VIRGINIA ELECTRIC AND POWER COMPANY
NORTH ANNA POWER STATION UNITS 1 AND 2
PROPOSED TECHNICAL SPECIFICATION CHANGES
IMPLEMENTATION OF ALTERNATE SOURCE TERM
REQUEST FOR ADDITIONAL INFORMATION

**Virginia Electric and Power Company
North Anna Power Station Units 1 and 2
Proposed Technical Specification Changes
Implementation of Alternate Source Term
Request for Additional Information**

NORTH ANNA ALTERNATIVE SOURCE TERM ARCON96 INPUTS, ASSUMPTIONS, MODELING OPTIONS AND RESULTS

FIGURE 1 – A SIMPLIFIED DIAGRAM OF
PORV STEAM FLOW

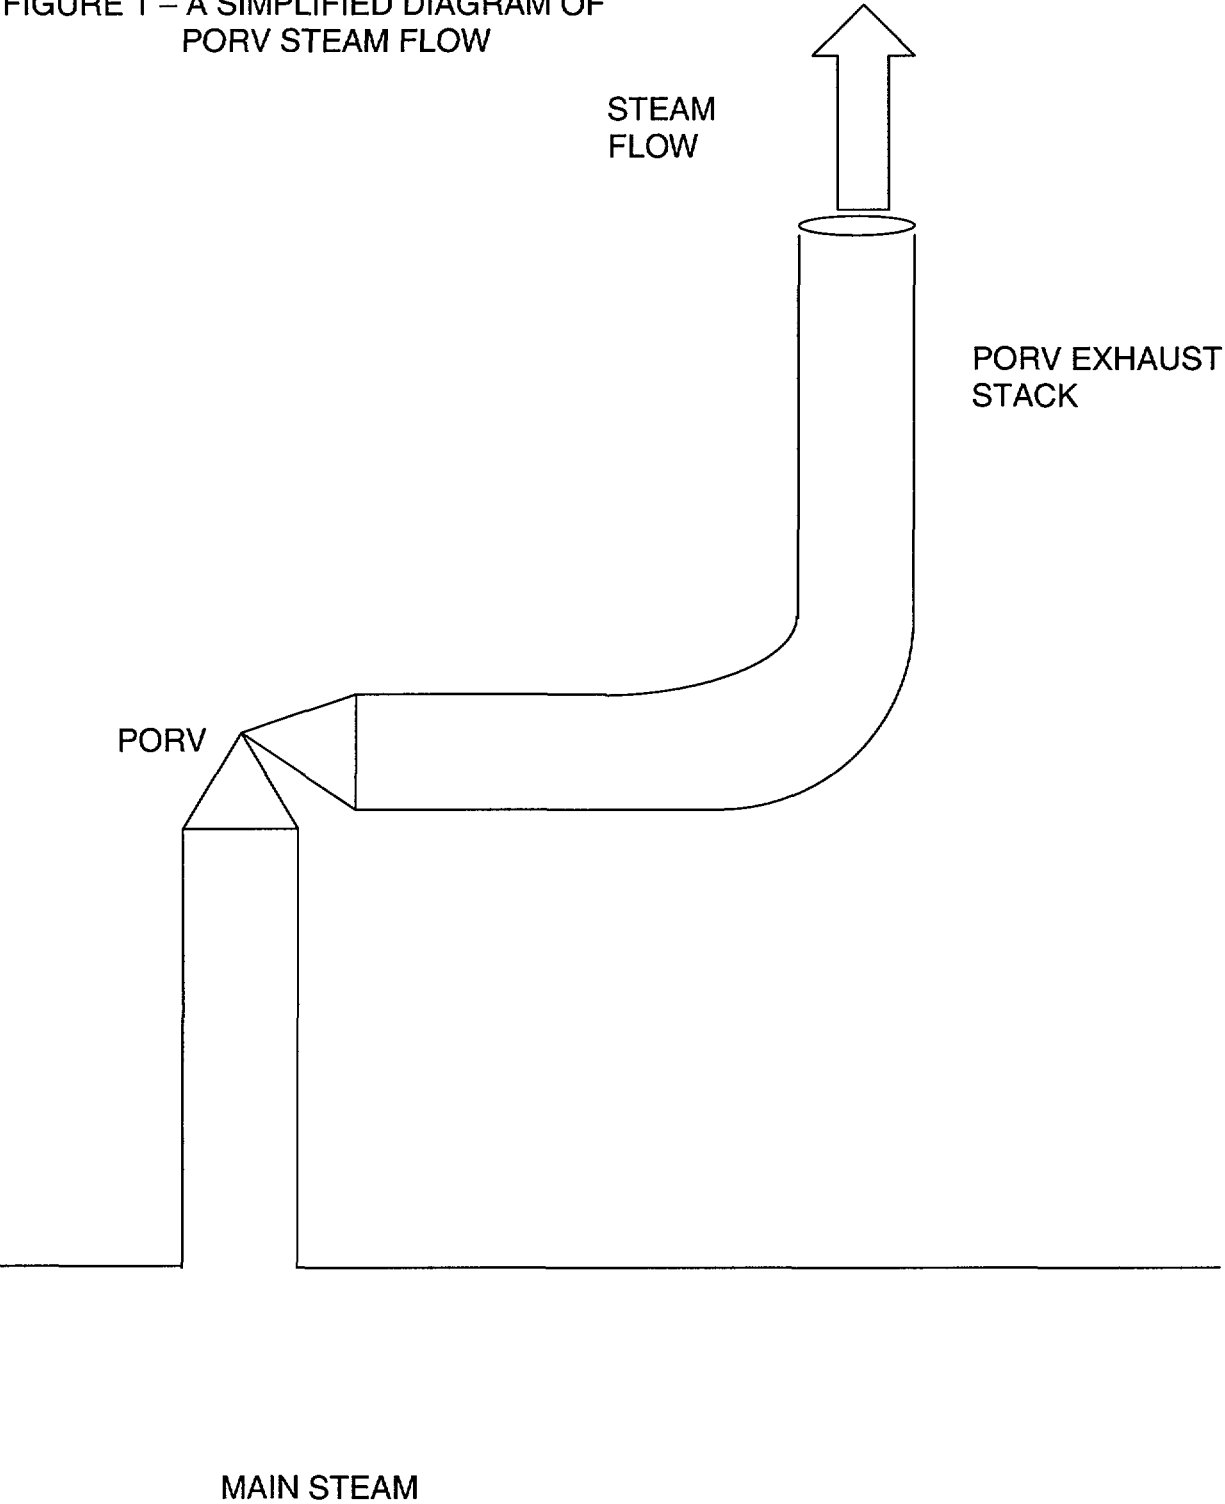
According to Regulatory Guide 1.194, atmospheric dispersion factors computed by ARCON96 for atmospheric relief valves can be reduced by a factor of 5 if two conditions are met. First, the flow from the valve must be vertical and must not be impeded. Second, the vertical velocity of the flow must be at least 5 times the 95th percentile wind speed at the elevation of the release. In the case of the PORVs for North Anna the

steam flow from these valves is vertical and unimpeded. See Figure 1 for a simplified arrangement of the steam flow path through a PORV. The vertical velocity of the steam exhausting these valves is conservatively estimated in the discussion below for the steam generator tube rupture (SGTR) accident.

By using the ASME Steam Tables for Industrial Use [Reference no. 2] in an iterative fashion, it was determined that saturated steam at a pressure of approximately 41 pounds per square inch flows 84.9 pounds of steam per second through a cross sectional area of 0.545 square feet at its choked flow velocity of about 1590 feet per second.

For the SGTR accident the minimum vertical velocity of the steam exiting a PORV exhaust stack is about 812 feet per second or about 248 meters per second. The 95th percentile wind speed at the elevation of the top of the PORVs exhaust stack is 5.72 meters per second. Five times 5.72 meters per second is 28.6 meters per second. Thus, the minimum vertical velocity of the steam at the point where it exits the PORVs exhaust stack is far in excess of the threshold needed to qualify for the factor of 5 reduction in ARCON96 calculated atmospheric dispersion factors.

Sketch No. 1

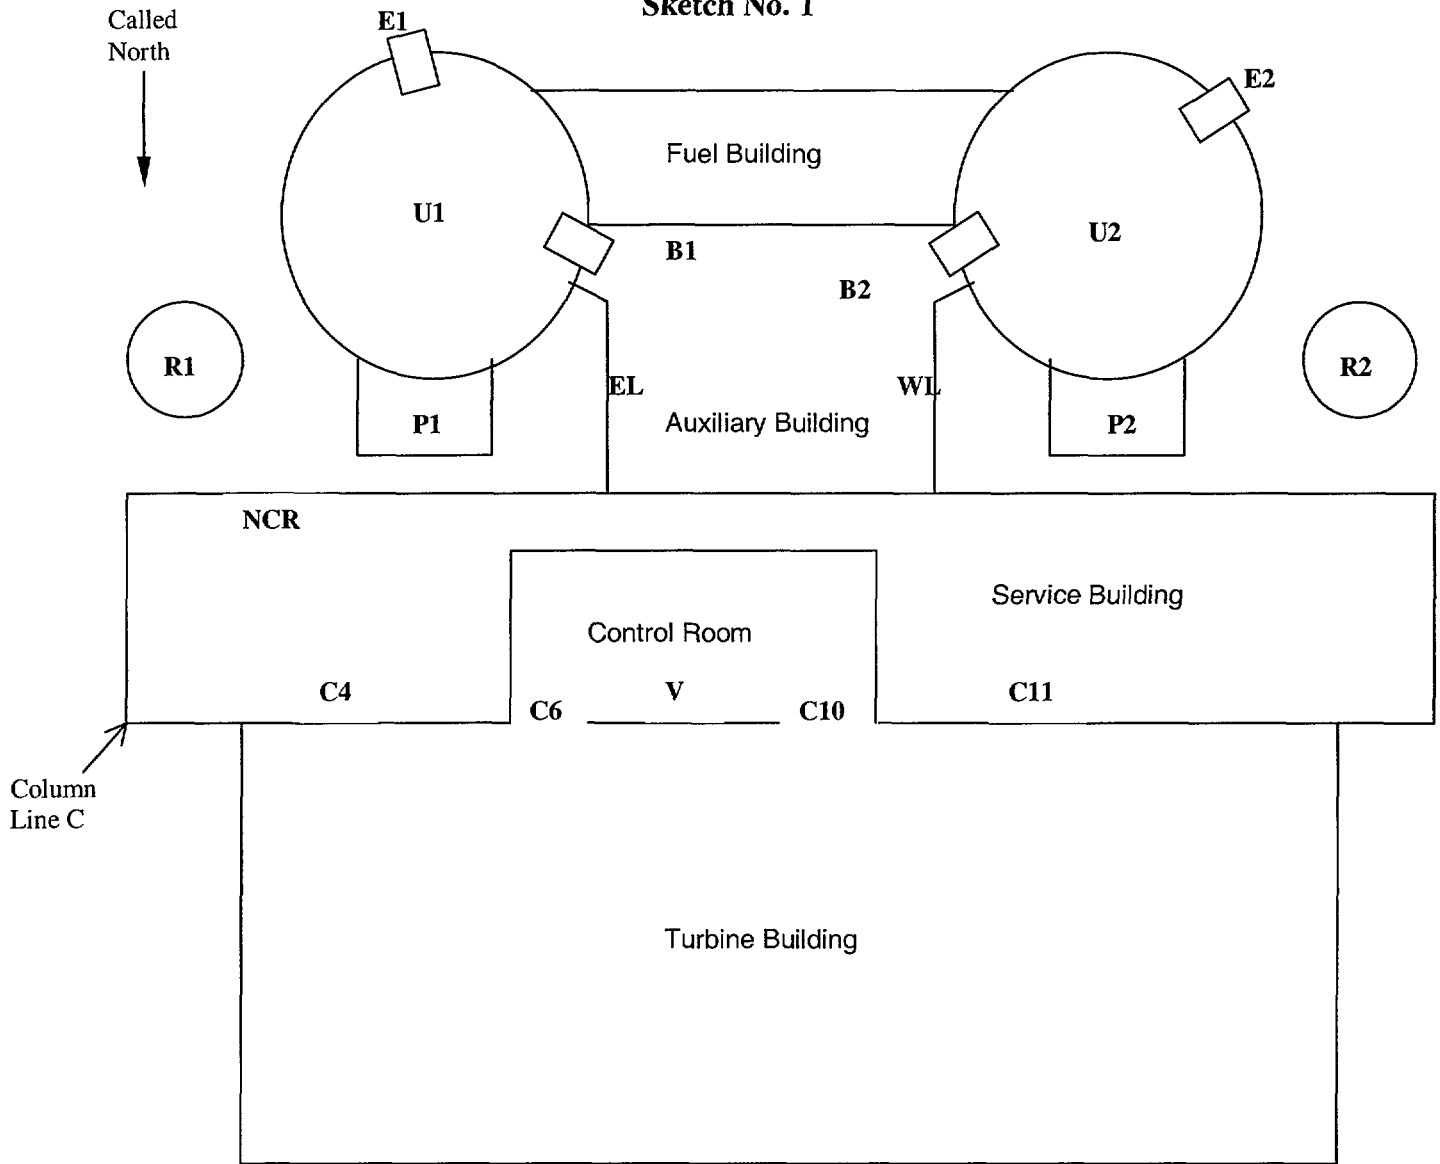
The location of each receptor and source are marked on Sketch No. 1, which is an attachment to this letter. The location designations for the receptors and sources on Sketch No. 1 are as follows:

Sketch No. 2

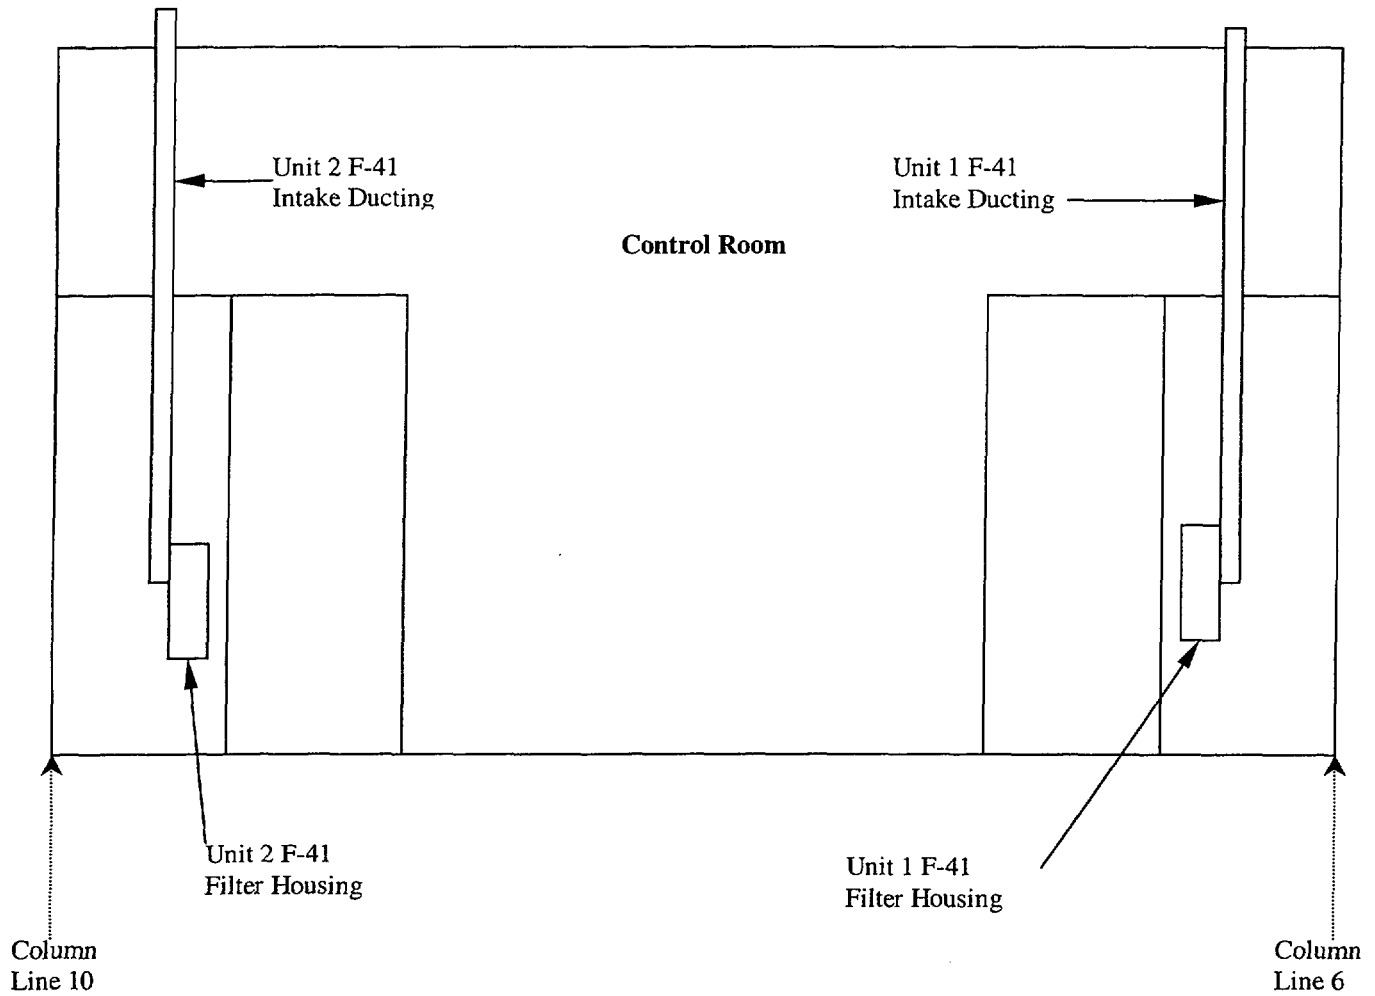
Sketch No. 2 shows the filter housings and intake ducting for the two F41 emergency control room fans. The intakes for these fans draw air from the turbine/service building air volume. One intake is close to column lines C and 10. The other intake is close to column lines C and 6.

Sketch No. 4

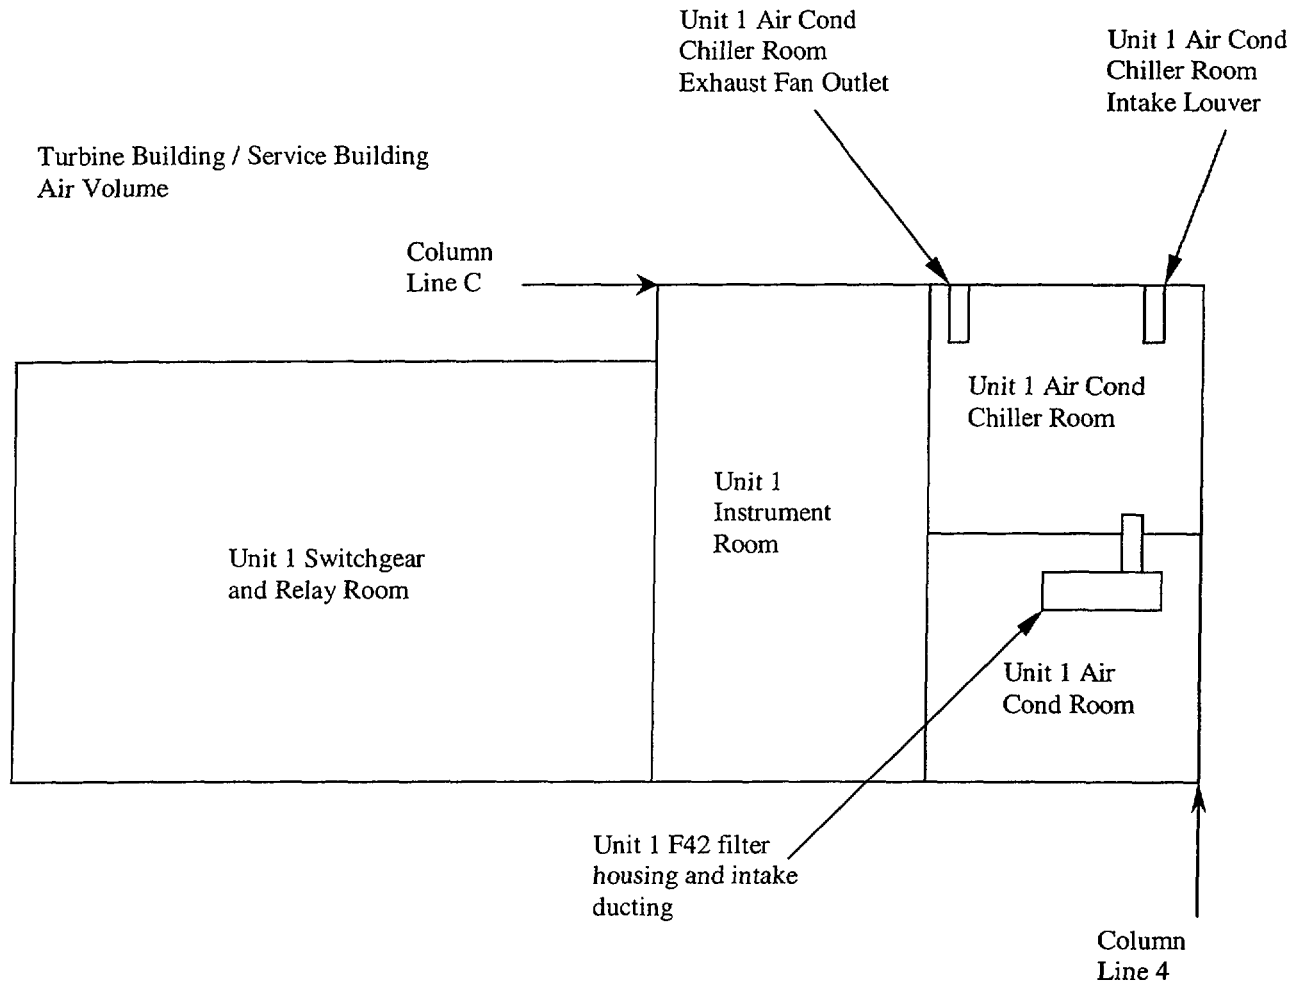
Sketch No. 4 shows the filter housing and intake ducting for the Unit 2 F42 emergency control room fan. The intake takes suction on the Unit 2 air conditioning chiller room and not on the turbine/service building. The air conditioning chiller room is within the control room concrete envelope (but not the control room pressure envelope) and communicates with the turbine/service building air volume via an exhaust fan and intake louver. The chiller room intake louver was modeled as the intake point into the control room envelope for the Unit 2 F42 fan. This intake point is referred to as the C11 receptor because of its proximity to column lines C and 11. See the assumptions section for more information about the selection of the intake point.
